Attachment E

Location and Type of NESC Violation

Re: Oncor Safety Violations

28

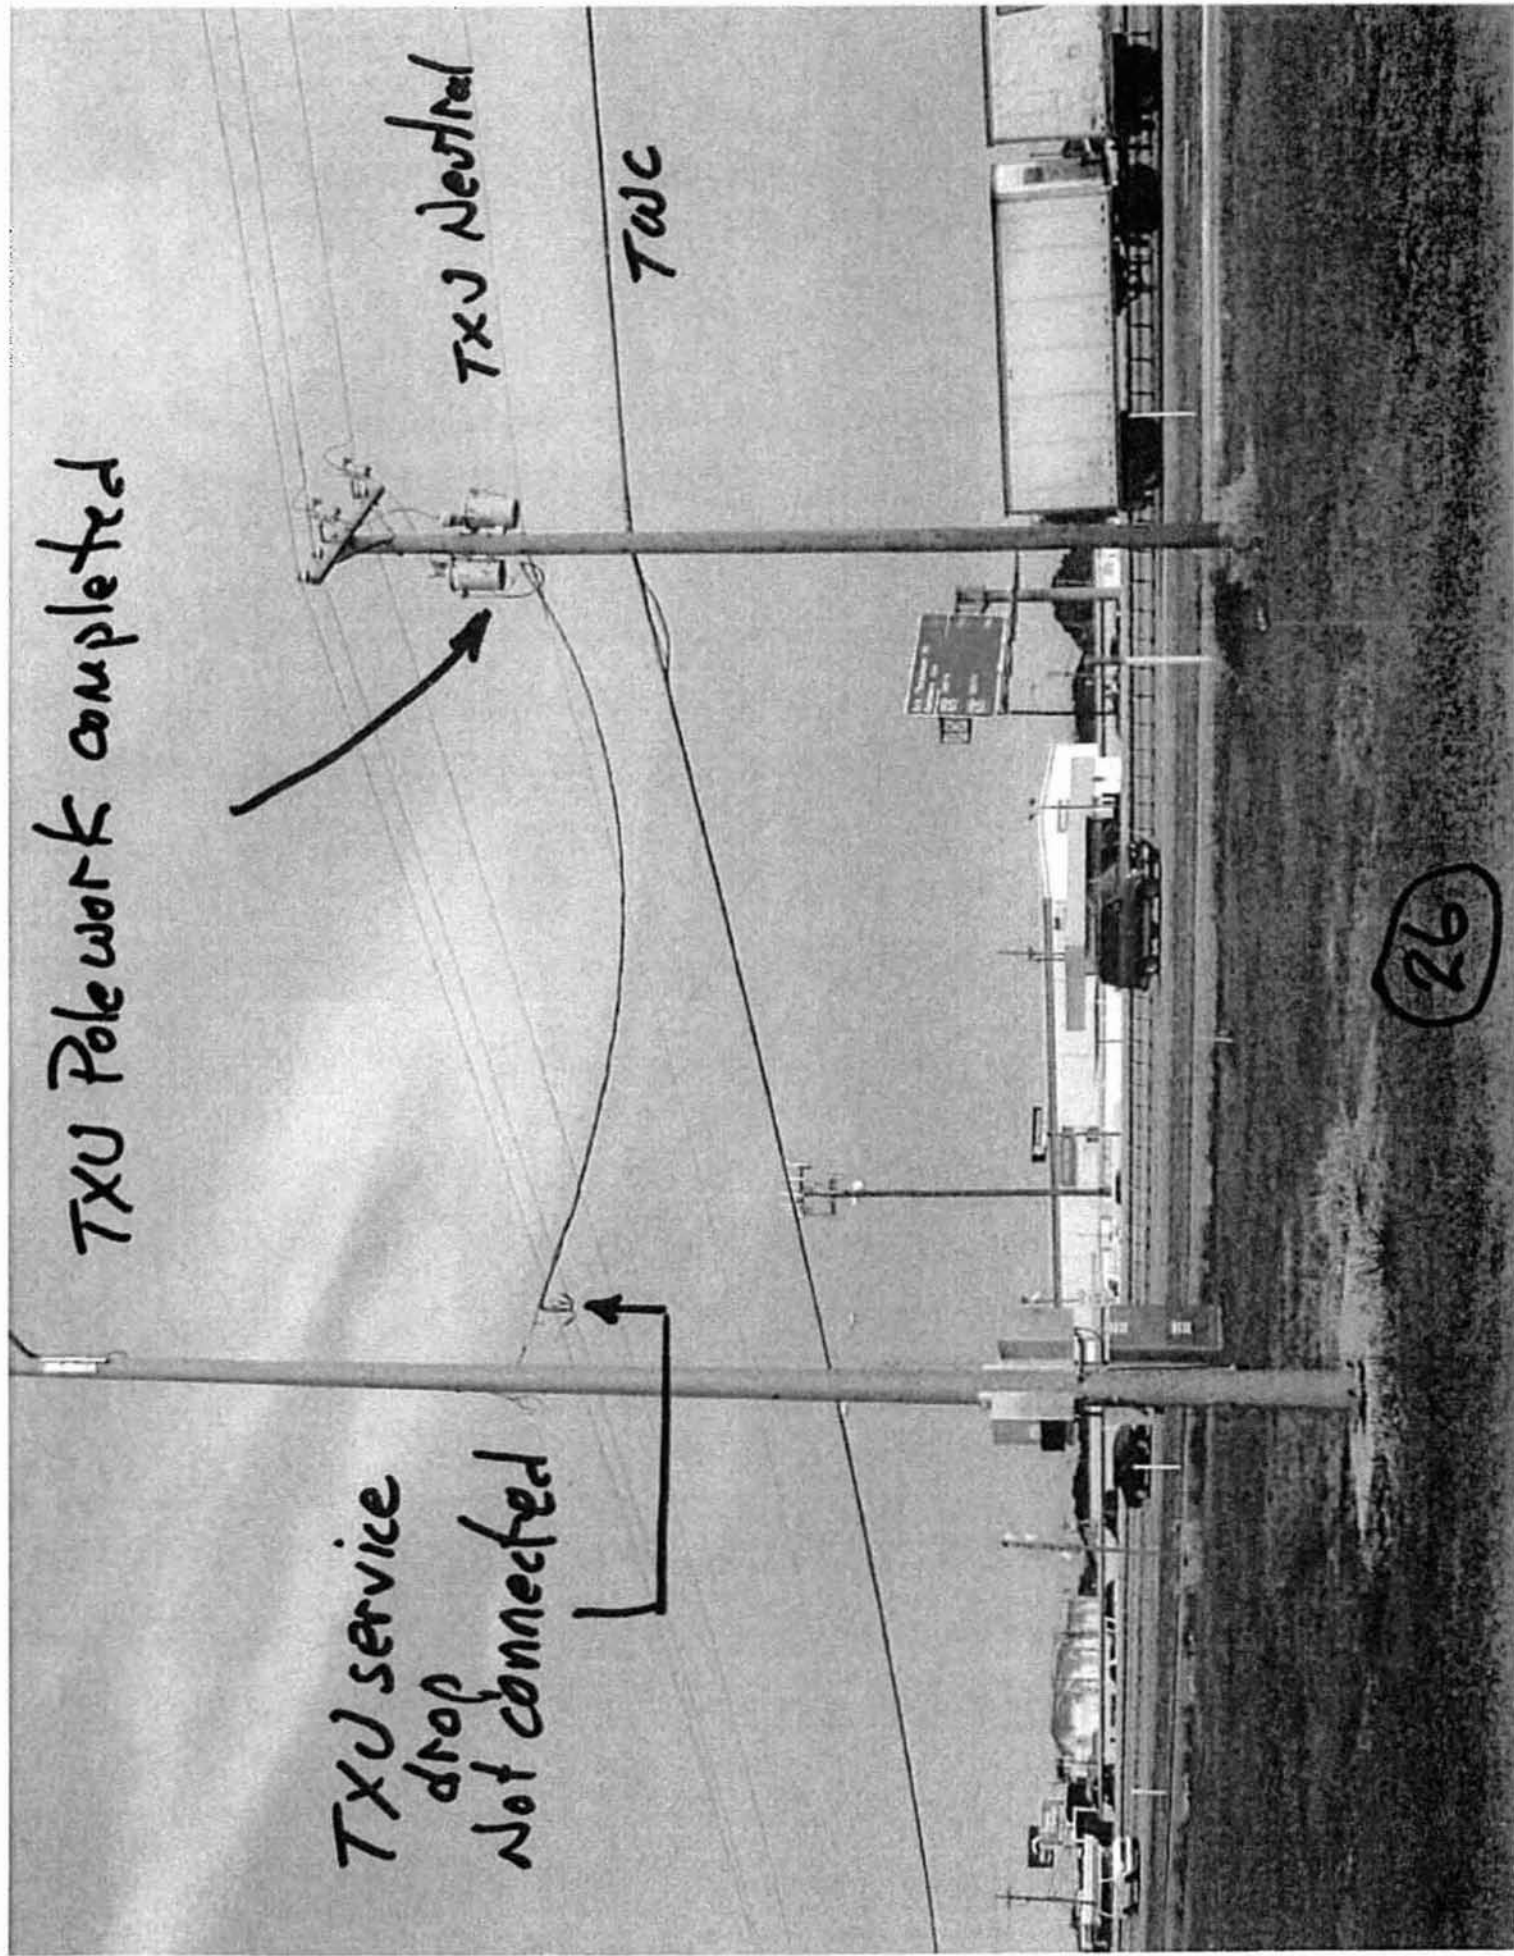
TXJ service
drop/transformer
leads coiled
and tied to
TWC

TXJ Transformer
leads

37"

Conduit ends
at City cable
